H11621

NOAA FORM 76-35A	
U.S. DEPARTMENT OF COMMERCE NATIONAL OCEANIC AND ATMOSPHERIC ADMINISTRATION NATIONAL OCEAN SURVEY	
DESCRIPTIVE REPORT	
Type of Survey	Hydrographic
Registry No.	H11621
LOCALITY	
State	Alabama
General Locality	Mississippi Sound
Sub-locality	Grand Bay to Petit Bois Pass
2006	
CHIEF OF PARTY Dean Moyles FUGRO PELAGOS, Inc	
DATE	LIBRARY & ARCHIVES

<p>REMARKS: The purpose of this work is to provide NOAA with modern debris mapping survey in the area of Mississippi Sound from Grand Bay to Petit Bois Pass.</p> <p>ALL TIMES ARE RECORDED IN UTC.</p> <p><i>Remarks in red, bold italics were made during AHB processing of this survey.</i></p> <p>FUGRO PELAGOS INC 3738 RUFFIN ROAD SAN DIEGO, CA 92123</p>

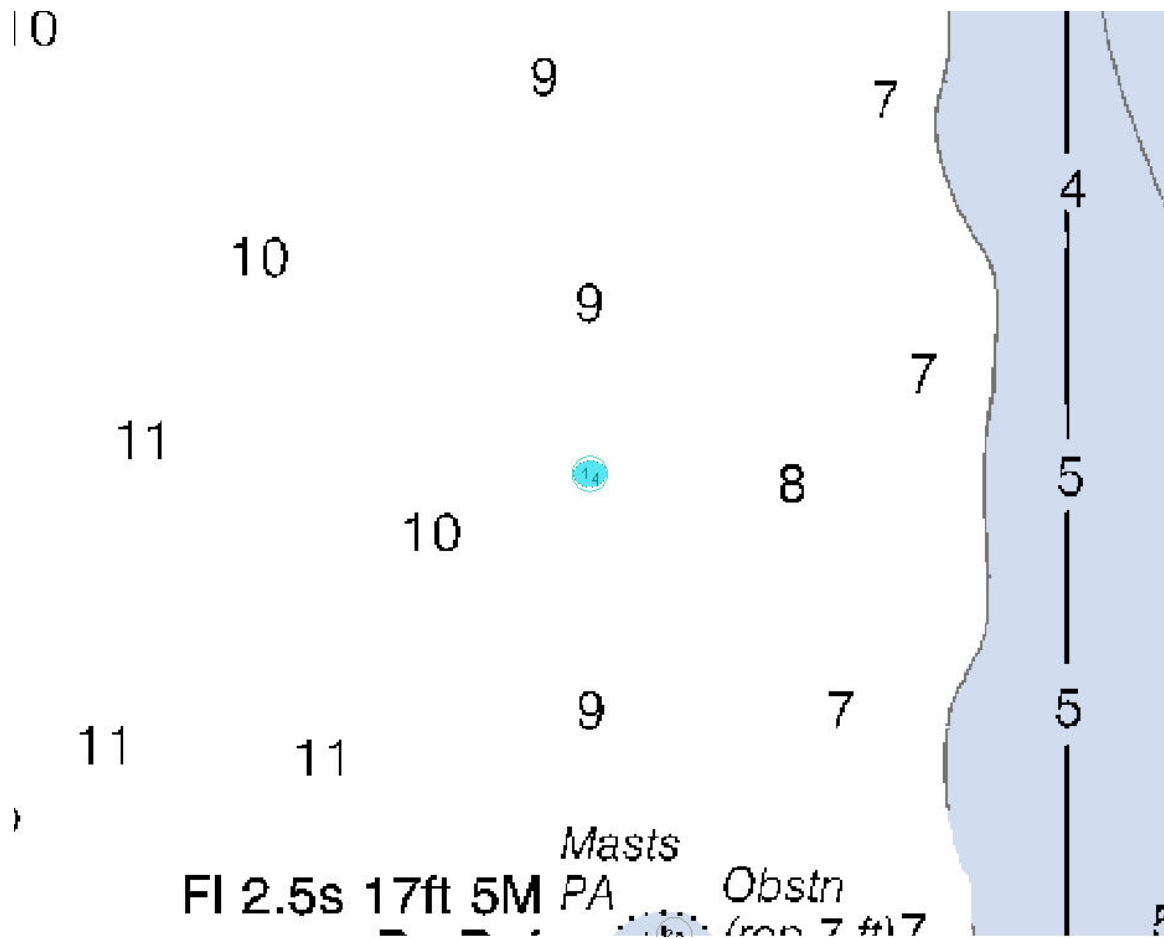
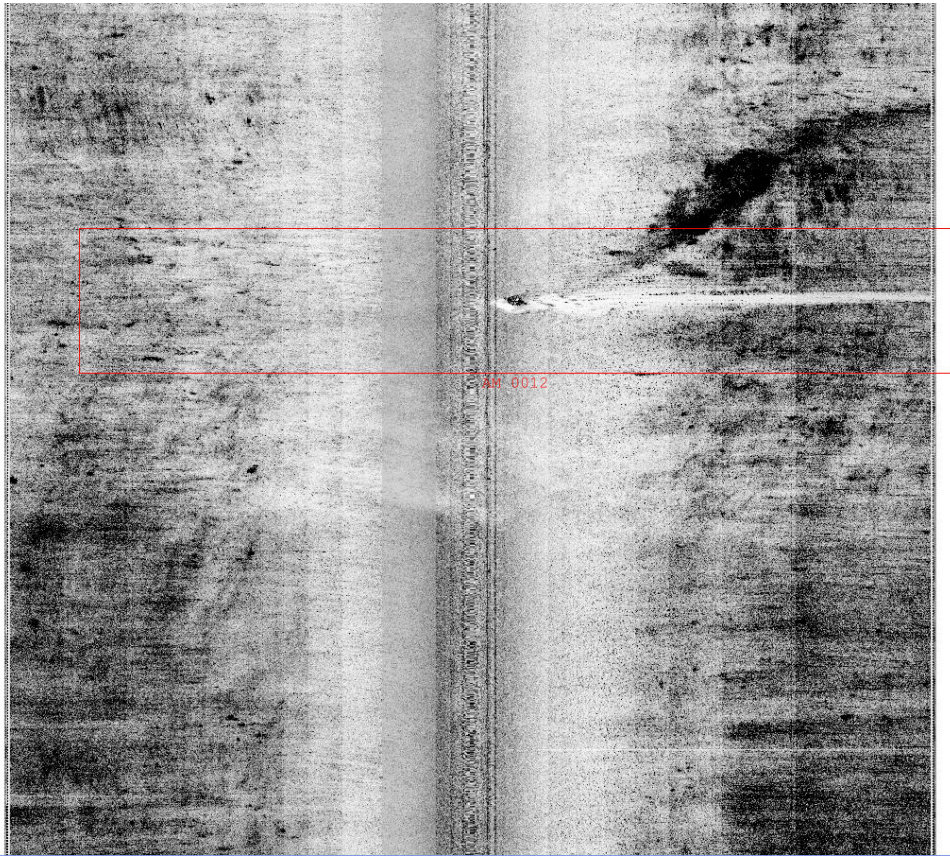
Figure 42-3 located at 30.31355977 N, **30° 18' 48.82"N**, 88.30676600 W **88° 18' 24.36"N** also appears to be a gas leak and not an actual feature.

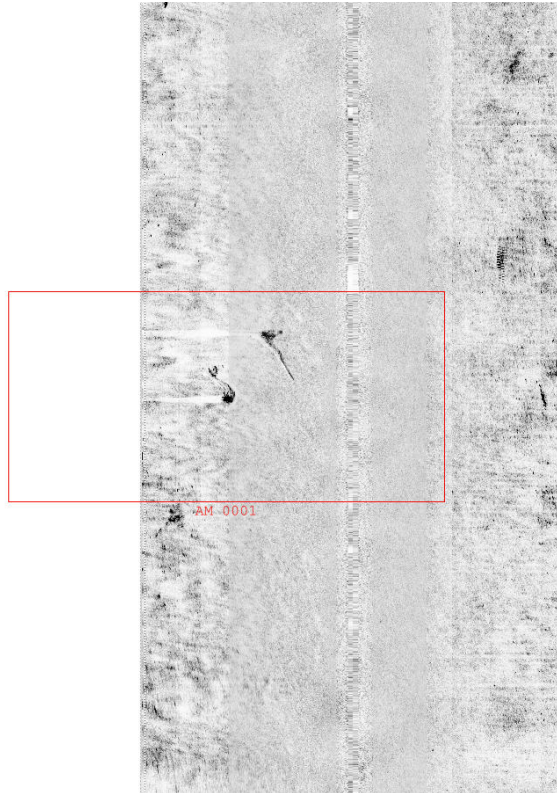
- Feature 42-3 again looks like a gas leak not a DToN contact. They have the positioning from 4 sss contacts and ran a single beam line over the contact. There is nothing in the single beam but a small hole, possibly where the seabed is being scoured under the pipe. Unsure if should be charted as a feature or submitted as DToN.

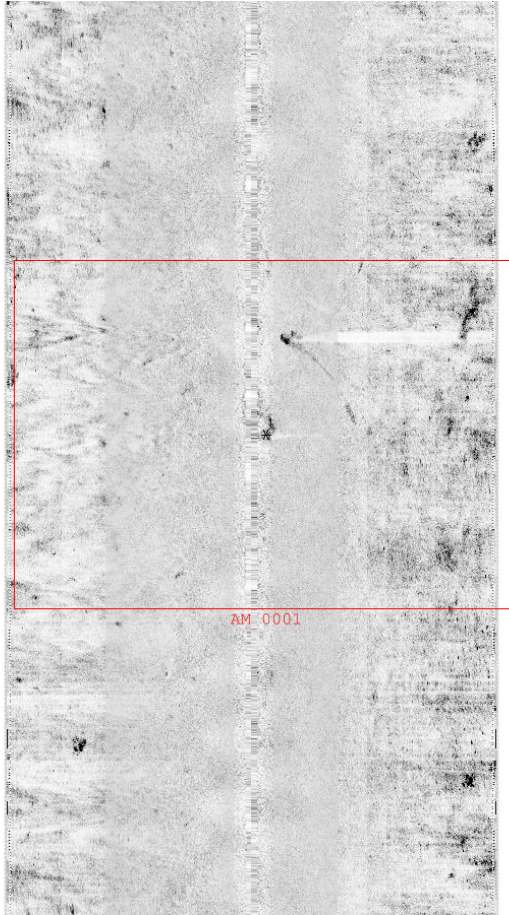
- Wreck PA located at 30° 14' 4.35" N 88° 15' 49.18" W not addressed in DR. There is not enough data available to disprove wreck therefore it is recommended to retain the wreck as charted. As such it was retained from the ENC.
- Wreck PD (rep cov 1ft) located at 30° 15' 39.88" N 88° 23' 32.45" W was neither address in DR nor was it fully developed and can not be disproven. It is recommended to retain as charted. As such it was retained from the ENC.
- Obstr located at 30° 18' 24.10N 88° 14' 14.95" was not addressed by the field in the DR. It is visible in the SSS and it is recommended to retain as charted. As such it was retained from the ENC.
- Address shifting shoreline around Dauphin Island in ER. Suggest defer charting disposition to MCD.
- Deleted four obstructions along the west side of Dauphin Island West Point and replaced with an area obstruction with unknown least depth.
